ANALYSIS OF MOBIL/TVA'S INTERIM MINING AND
RECLAMATION PLAN FOR PILOT TESTING OF IN SITU LEACHING
AT CROWNPOINT, MCKINLEY COUNTY, NEW MEXICO, MAY 1978

June 19, 1978

MOBIL OIL CORPORATIONS

FIGURE 1

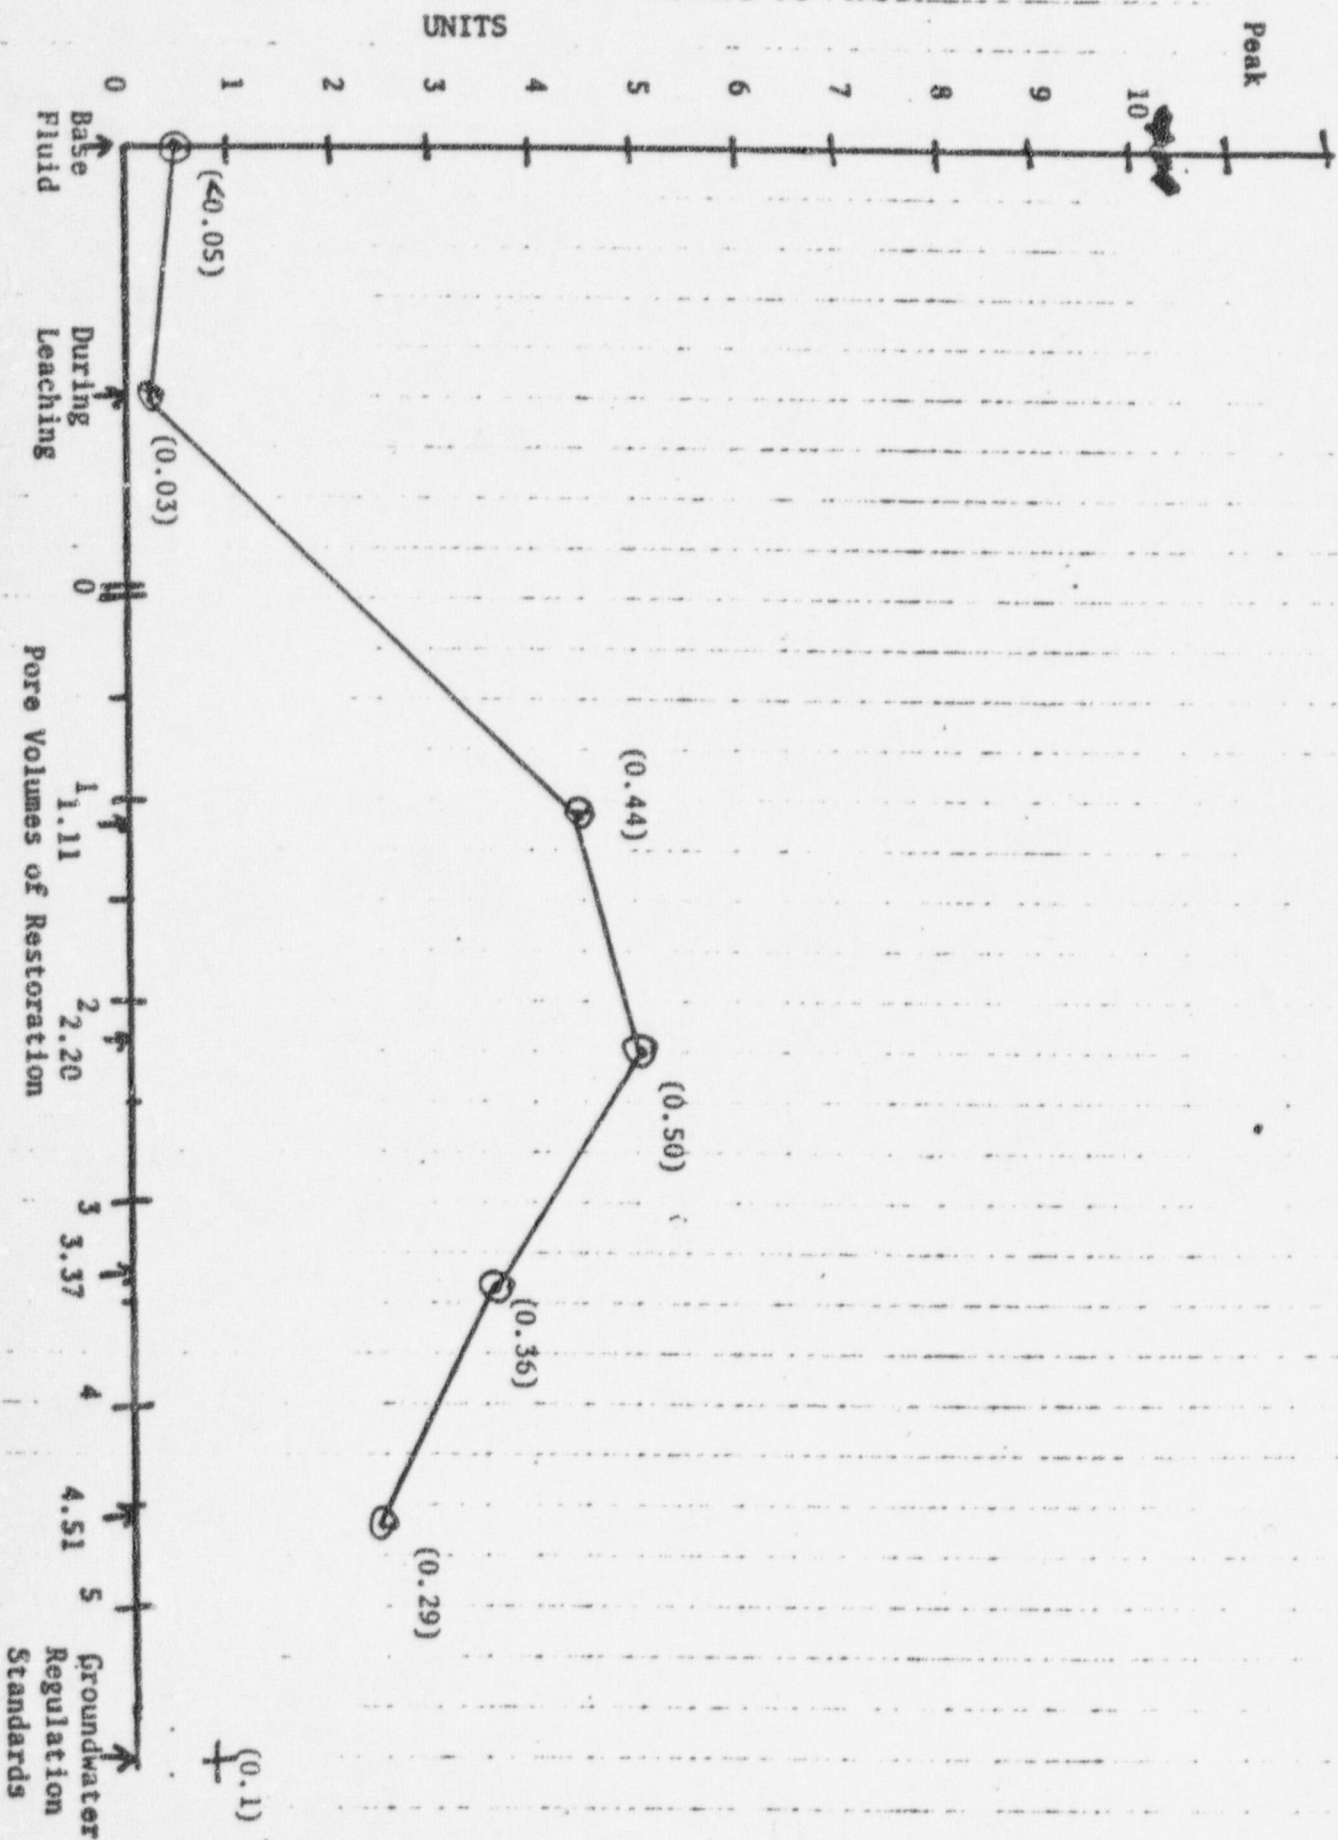
The Lab scale tests of restoration of Westwater Canyon member water quality are included at p. 39 of the Mining Plan. Selected parameters in this table have been graphed to show their trends in relation to the New Mexico Groundwater Quality Regulations and the base fluid, close to present natural water quality. The parameters graphed include: arsenic, molybdenum, selenium, uranium, and radium-226. These represent a sample of pollutants of concern in uranium mining water quality impact assessment. See Figures 1-5. Inspection of these figures show reduced cleansing with increased flushing. Restoration efficiency decreases with increased pore volumes of flushing.

Analysis of the Lab scale restoration effort shows:

<u>Parameter</u>	<u>Factor by which 4.51 p.v. restoration exceed New Mexico Groundwater Standards</u>
Arsenic	2.9
Molybdenum	4.6
Selenium	5.4
Uranium	3.4
Radium-226	6 (assumes Ra-226 and Ra-228 standard and no Ra-226)

FIGURE 4

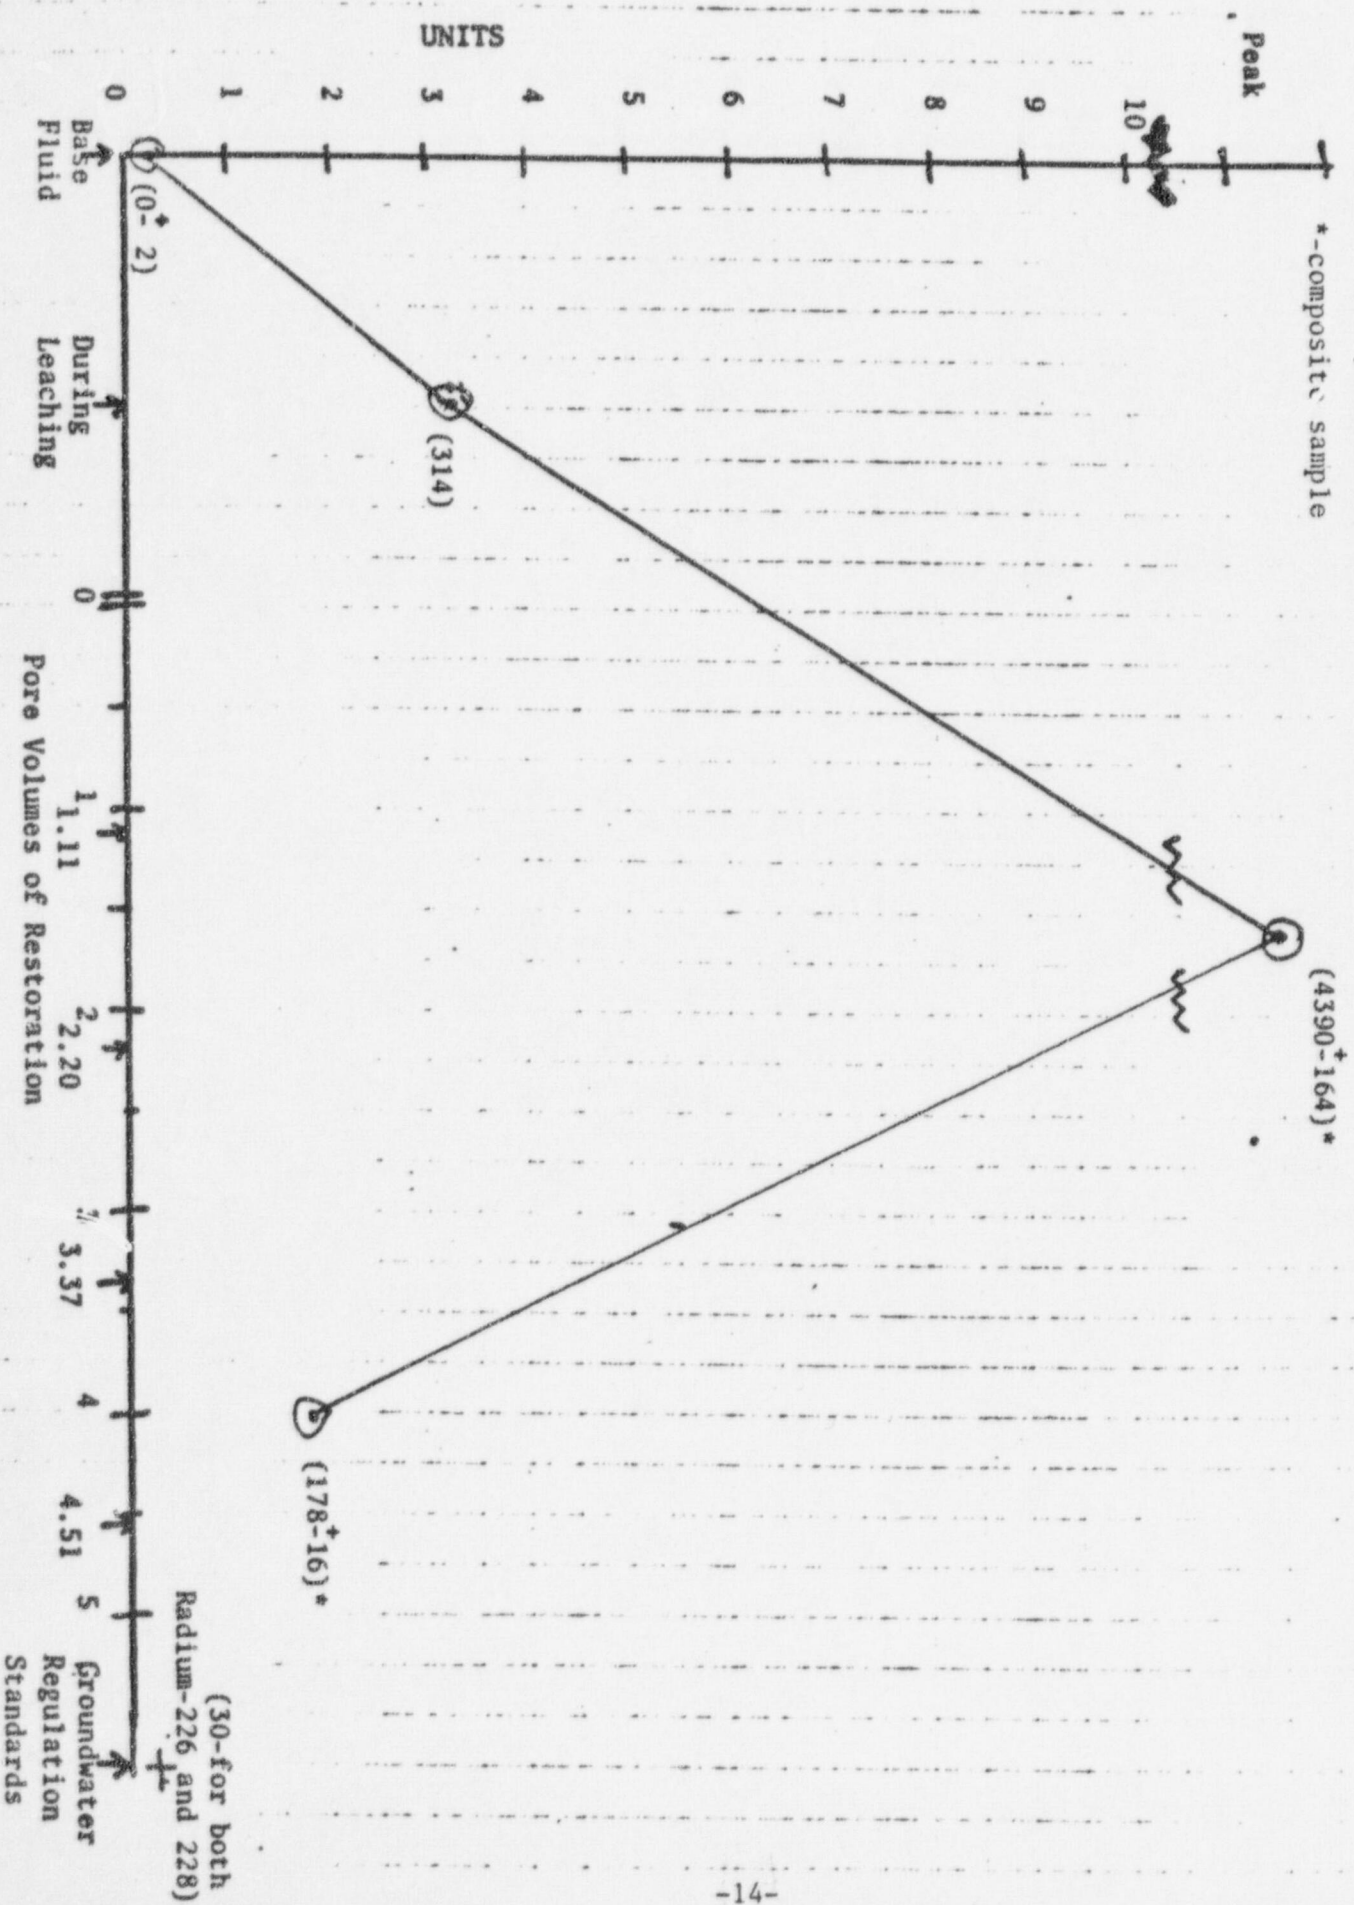
The radium measurements are particularly important. This material has the lowest allowable concentrations and the poorest quality data of any of the key parameters graphed. The table also fails to distinguish between dissolved and total radium-

226. The table on p. 39 should present a full analysis of radium (and by analogy other radioactive parameters). Radium is the most hazardous compound of any of the array of toxic compounds the in-situ project will utilize.
